**CASE SUMMARY SHEET****CASE NUMBER: SUP24-03-03****DATE RECEIVED: February 23, 2023****DATE OF MEETING: March 12, 2024 and March 26, 2024****Address: 1943 Lakeshore****Subdivision: City of Mandeville, Square 2 Lot 2A****Zoning District: B-3 Old Mandeville Business District****Property Owner: Cayman Sinclair****Previous Case: Z15-08-09**

**REQUEST: SUP24-03-03 – Cayman Sinclair requests a revision to Special Use Approval Z15-08-09 per CLURO Section 4.3.2.11. Amendments to Special Use Permit Approvals, City of Mandeville, Square 2 Lot 2A, B-3 Old Mandeville Business District, 1943 Lakeshore Drive**

**CASE SUMMARY SHEET****CASE NUMBER: V24-03-13****DATE RECEIVED: February 23, 2023****DATE OF MEETING: March 12, 2024 and March 26, 2024****Address: 1623 Lakeshore****Subdivision: City of Mandeville, Square 5 Lot 5A****Zoning District: R-1 Single Family Residential****Property Owner: Johnny Swiger**

**1** PROPOSED SITE PLAN  
1/8" = 1'-0"

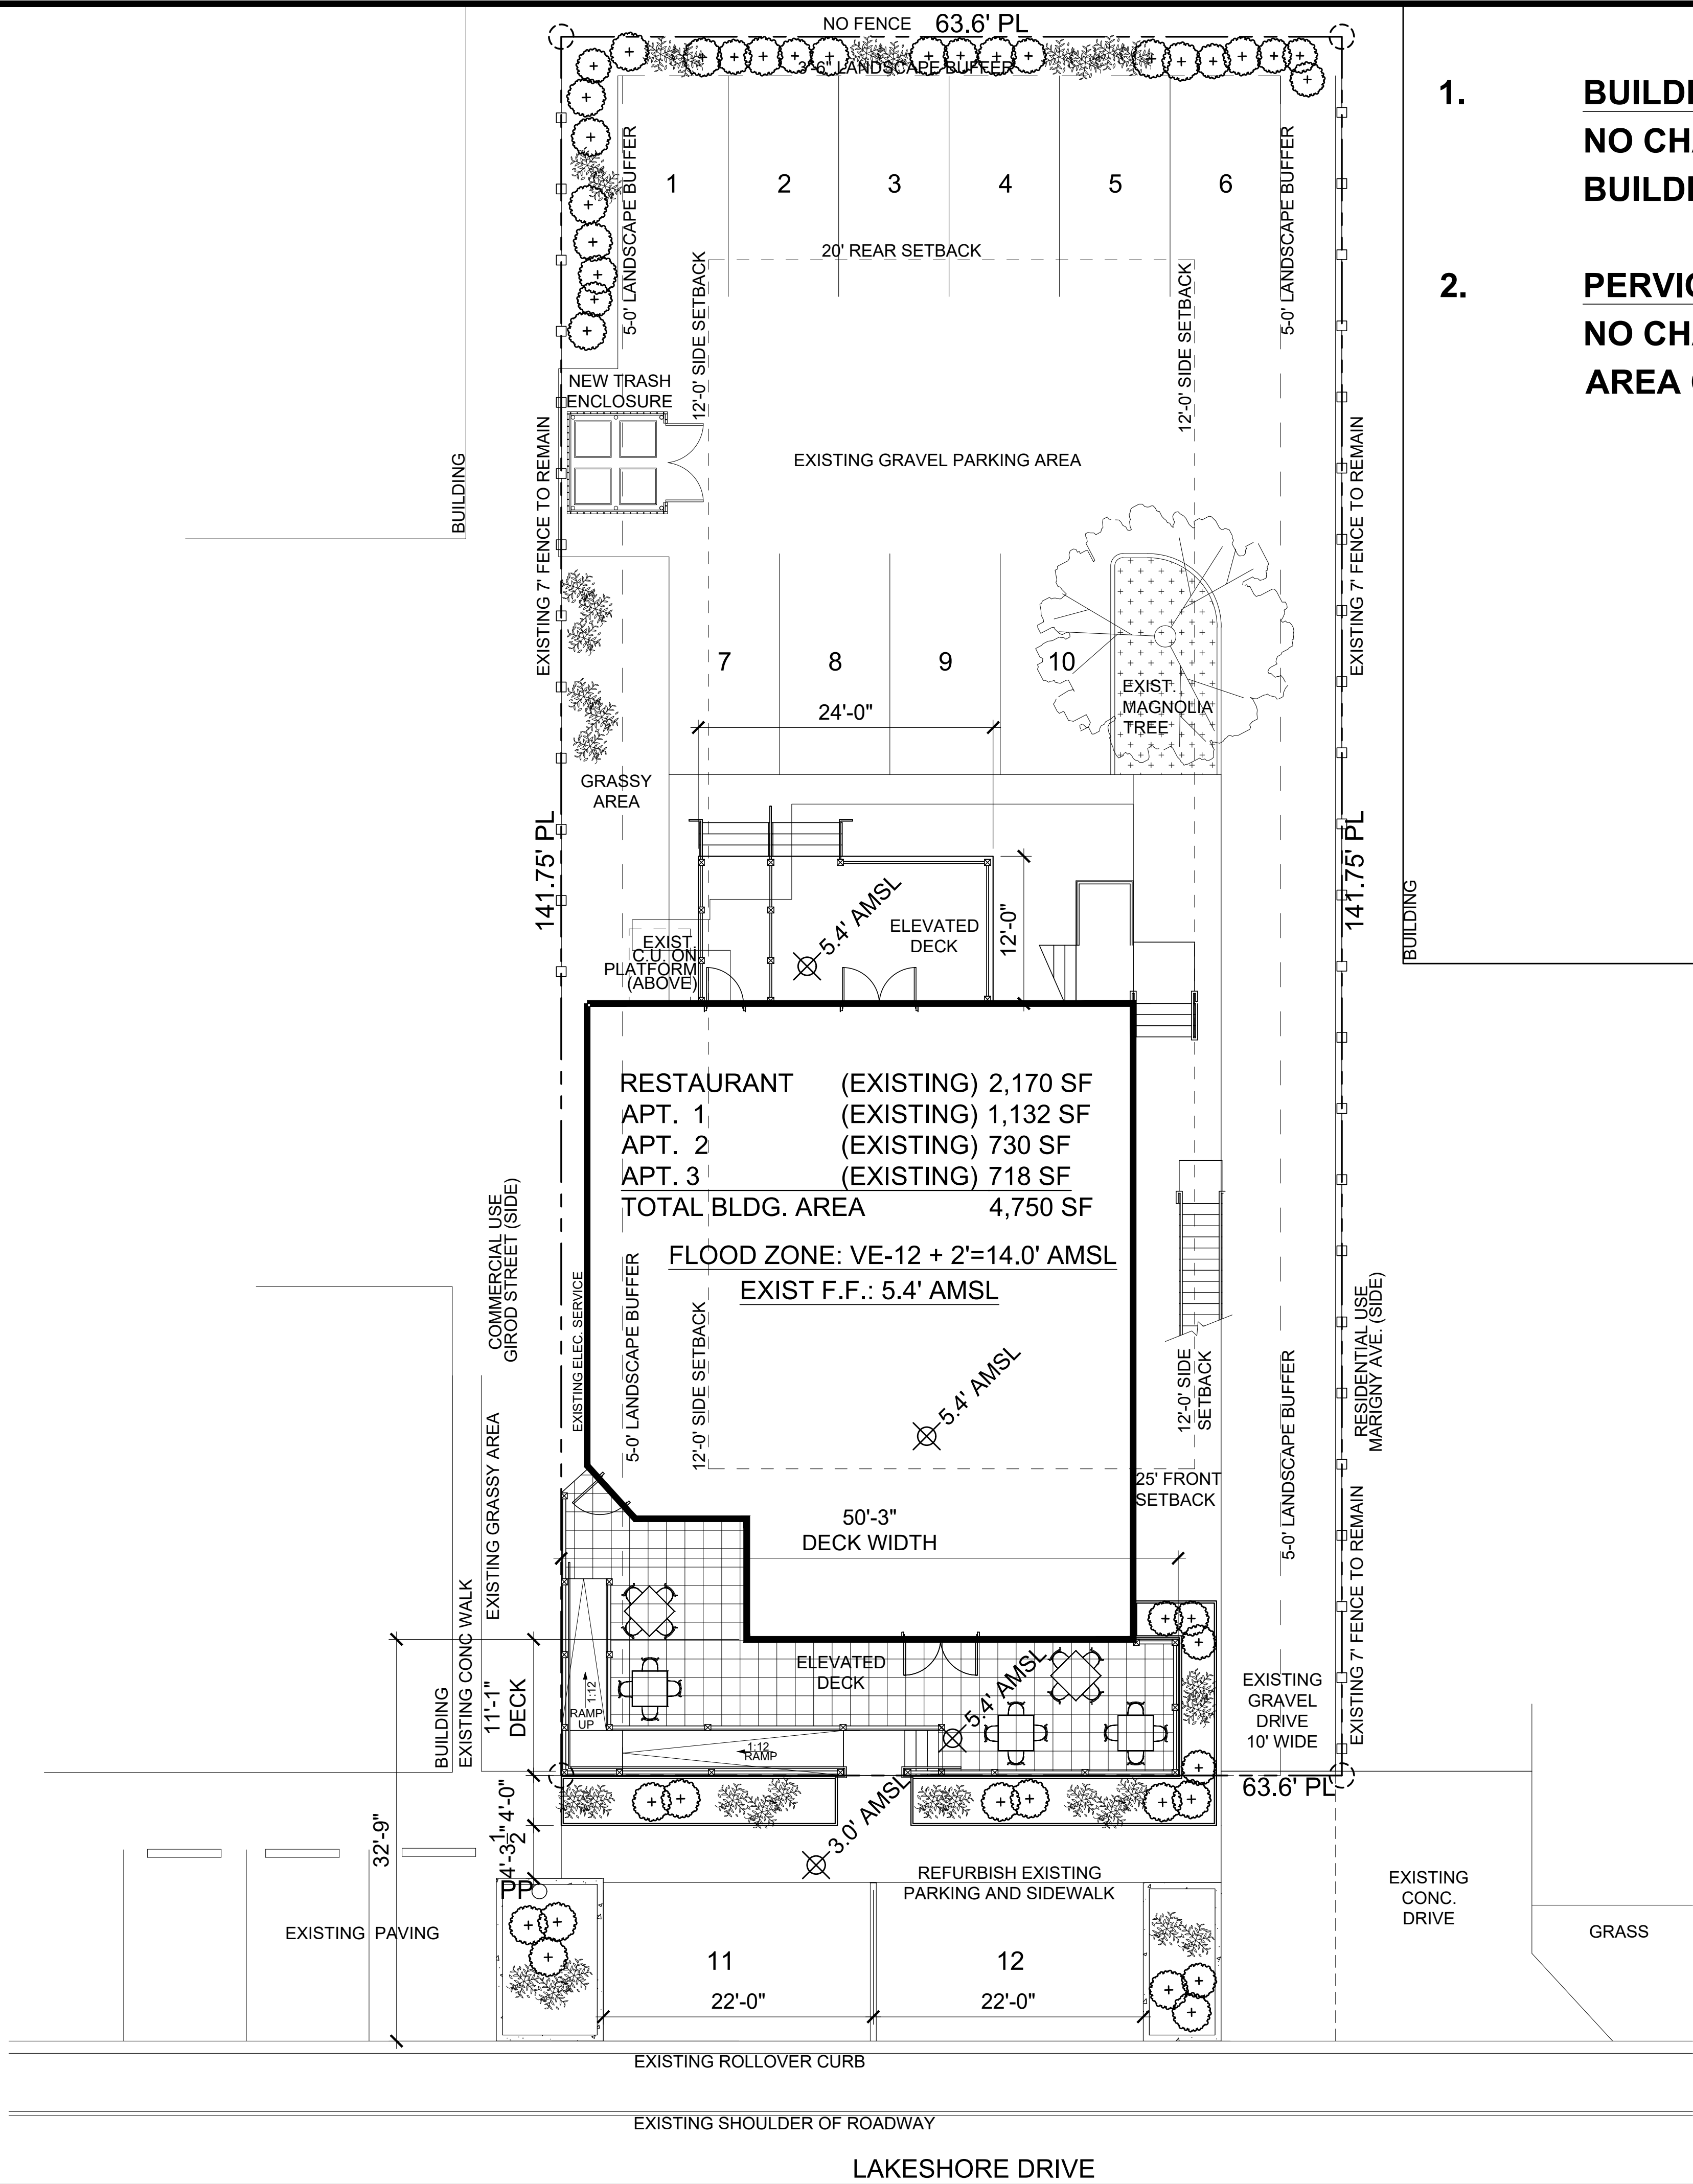
The previous approval allowed for ten parking spaces for the site. The applicant is proposing to add two additional parallel parking spaces in front of the building. The 2015 approval stipulated that the applicant was to remove the parking spaces in the front of the building and install greenspace. It is recommended by Dept. of Public Works that if the parking spaces are approved, they should be parallel as the perpendicular spaces are not sufficient in length.

The current building encroaches into the west side setback by 9'-8 1/2", and the front setback by 13'-11". The applicant is requesting to encroach up to the property line on both the west and front side to rebuild the previously existing front deck that was destroyed during Hurricane Ida.

The site currently has 82.8% impervious area coverage and 17.2% pervious area coverage. The B-3 site development criteria requires a maximum of 75% impervious coverage. This would require a variance of 7.8% impervious coverage. The applicant stated there would be no change to the pervious area on the site.

1. **BUILDING SETBACKS  
NO CHANGES TO EXISTING  
BUILDING SETBACKS.**
2. **PERVIOUS AREA  
NO CHANGE TO PERVIOUS  
AREA ON SITE.**

**DRAINAGE PLAN**  
1"=10'-0"

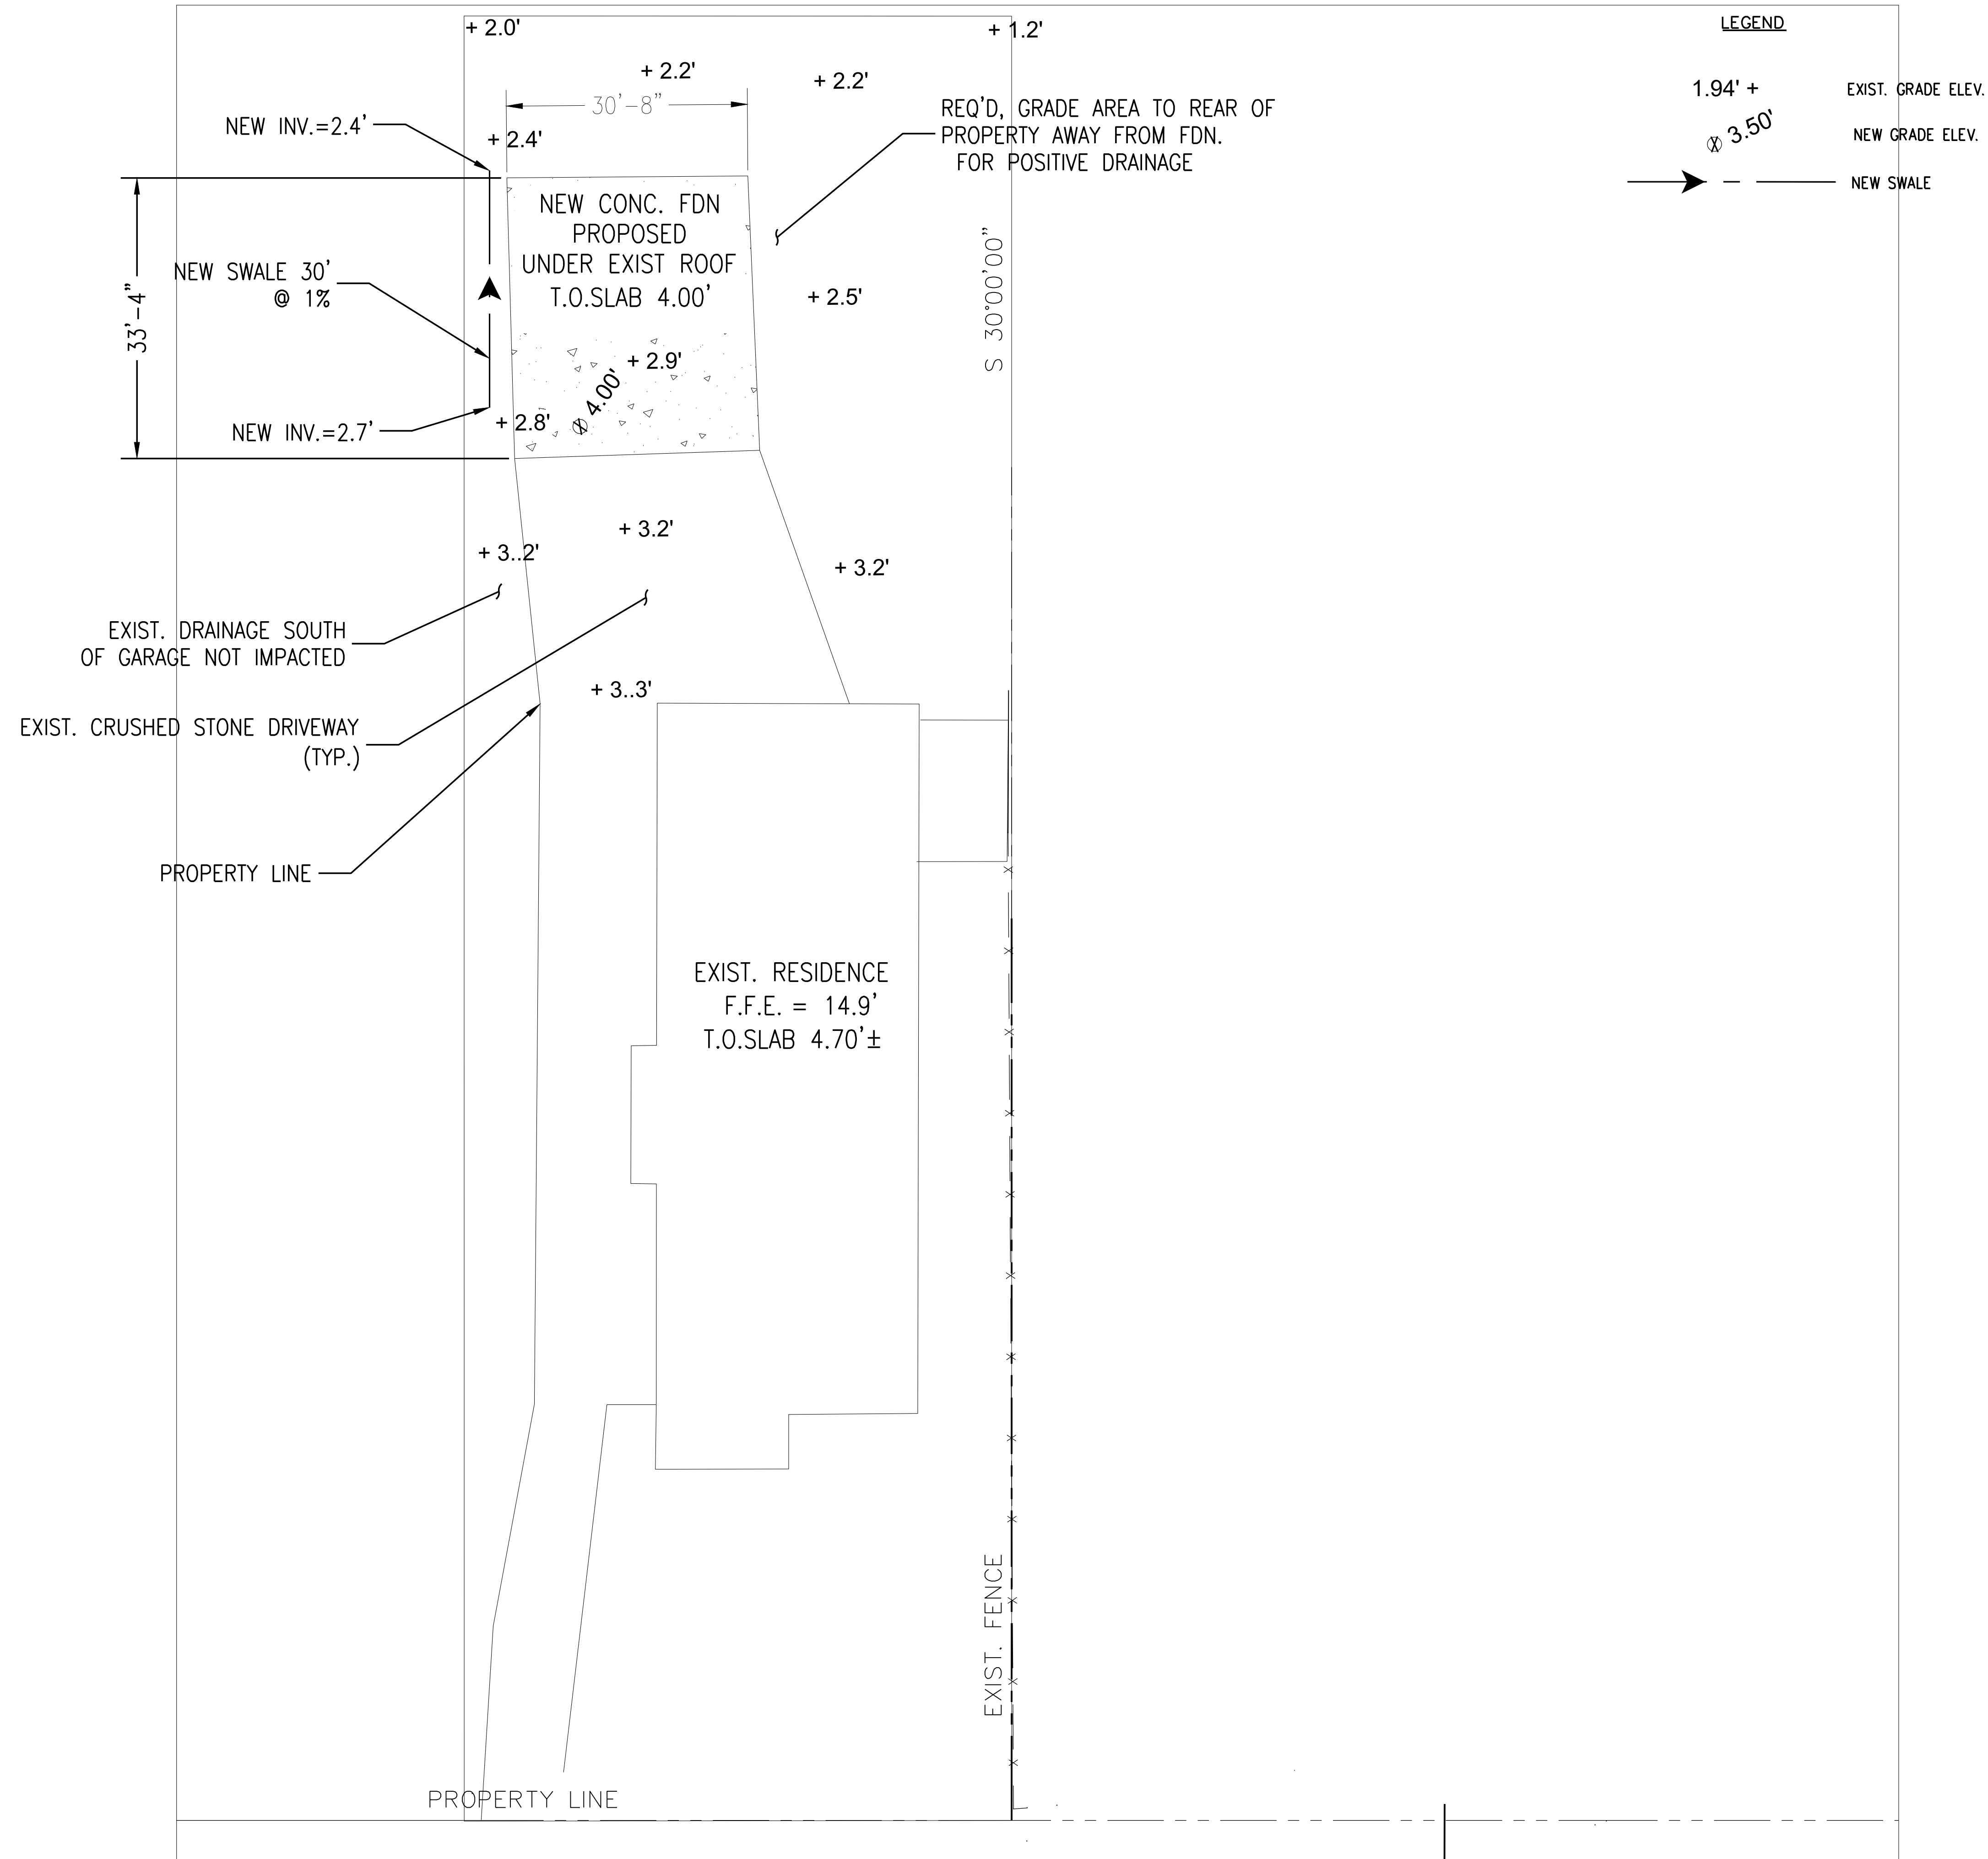
1. The proposed "REQ'D, GRADE AREA TO REAR..." does not have any proposed elevations or limits shown. The existing elevations demonstrate there is positive drainage to the rear and not necessary to fill.

2. The site plan indicates a walkway from the porch to the garage. This is not shown on the drainage plan and does not have any elevation data. If the walkway is to be elevated above 6" from grade, then the walkway should be included in the variance request.

3. Drainage Plan by Brain Froeba indicates a slab height of 4.00, site plan from John Bonneau shows a proposed FFE of 4.70. What one is the correct requested height?

4. The proposed is in the City's drainage overlay district and will require a Coastal Use Permit. Additional restrictions may apply pending there review.
